## Change Note of DFR0524 V2.0

### Appearance V1.0

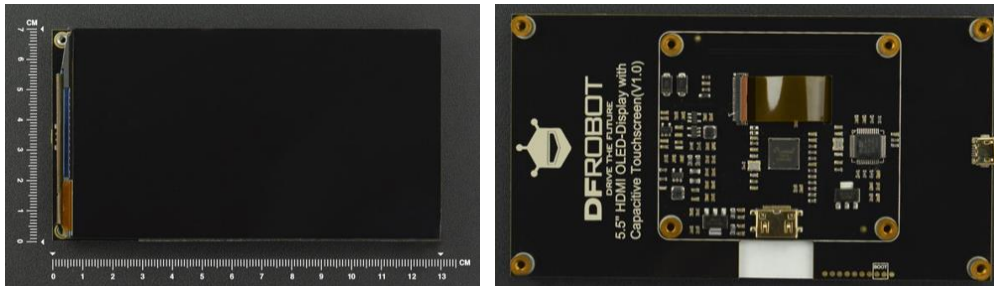
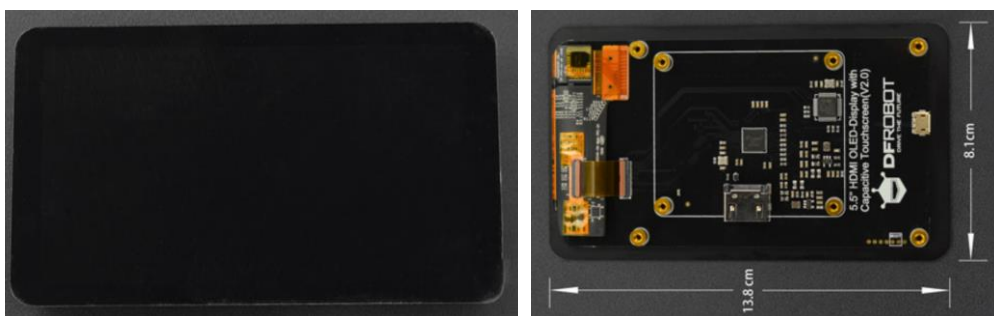
1. Dimension and Mount Holes  
Please kindly note that V1.0 and V2.0 is different in dimension and mount hole position.
2. Screen  
There is no cover in the surface of V1.0.  
While V2.0 is covered by a tempered glass to protect the screen from external force damage.
3. HDMI Socket  
V1.0 adapts HDMI- type C  
V2.0 adapts HDMI- type A
4. Power Supply  
V1.0 support HDMI or USB port power supply, while HDMI socket is limited in charging which may lead to unstable power supply.  
To guarantee stable voltage and current, V2.0 only support USB port power supply.
